N O R T H S Y D N E Y C O U N C I L R E P O R T S

ADDRESS: 55 Wycombe Road (aka 60 Shellcove Road) Neutral Bay (Lot 4 DP 580525)

APPLICATION No: 261/23

PROPOSAL: Alterations and additions to a dwelling house and associated works

Attic floor plan, showing new dormer for stairway, coloured, not to scale (Archer Design).

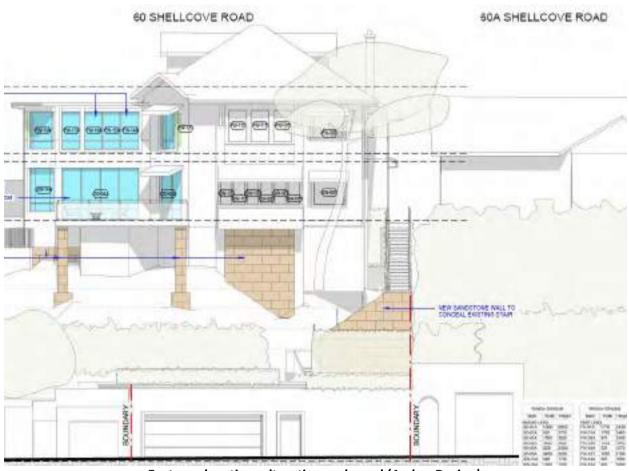
The proposed dormer is set in the rear roof plane and its form and scale is compatible with the existing building and to which no objections are raised.

The proposed dormer has a "dominating appearance", is not characteristic in the neighbourhood and is not within the "relevant building envelope", it is above the maximum height.	Considered elsewhere in this report. A revised clause 4.6 request for the amended design has been submitted, to vary the height standard.
Increased intensification of use of the access easement has not been assessed.	Should the application have been recommended for approval, use for construction purposes would be subject to limitations imposed by the instrument applying the right of carriageway to the land, if any. Post-construction use of the lane would be similar to current use.

Western elevation, alterations and additions coloured (Archer Design)

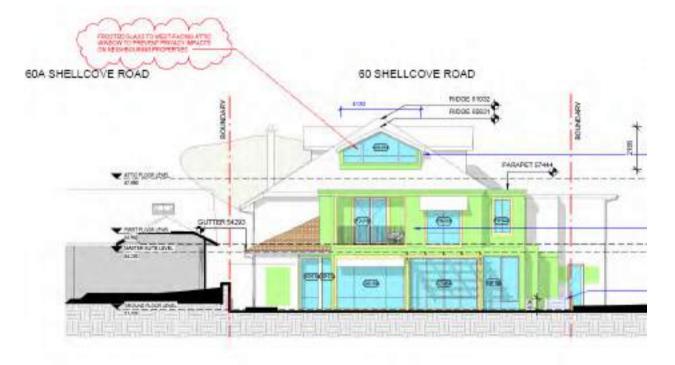
- That privacy is maintained, is arguable and requires qualification. The large expanse of obscure glass as proposed for the dormer would be a poor design outcome. It is apparent that the amount of glazing could be reduced and still provide enough light into the area above the new stairway to the attic, for which the dormer is necessary. It would also appear possible to reduce the size of the dormer, however this may not adequately resolve the impact on roof form of the third dormer. Another solution to accessing the attic (currently a pull-down step-ladder) is necessary. Another qualification was outlined above, in that where there is a transition from low to medium density, greater building separation than is available could be considered necessary.

Section showing the 8.5m building height limit, the existing building height of 9.7m and the proposed dormer that is to a height of 9.4m

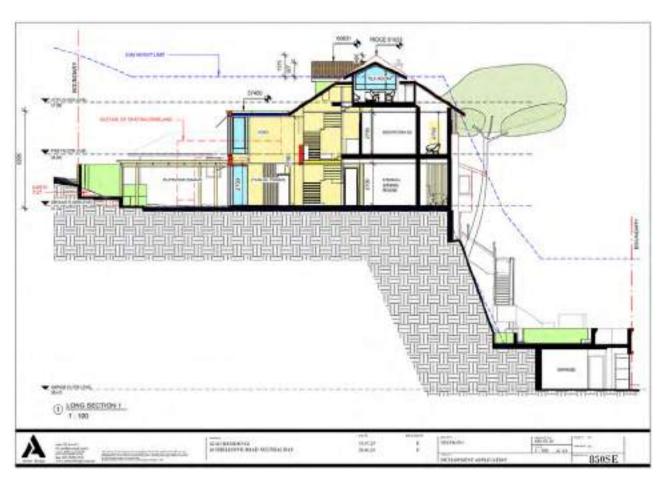
In response to each of the grounds in support of the height breach:

This analysis of the applicant's submission indicates the proffered environmental planning grounds are insufficient to justify non-compliance with the height control.
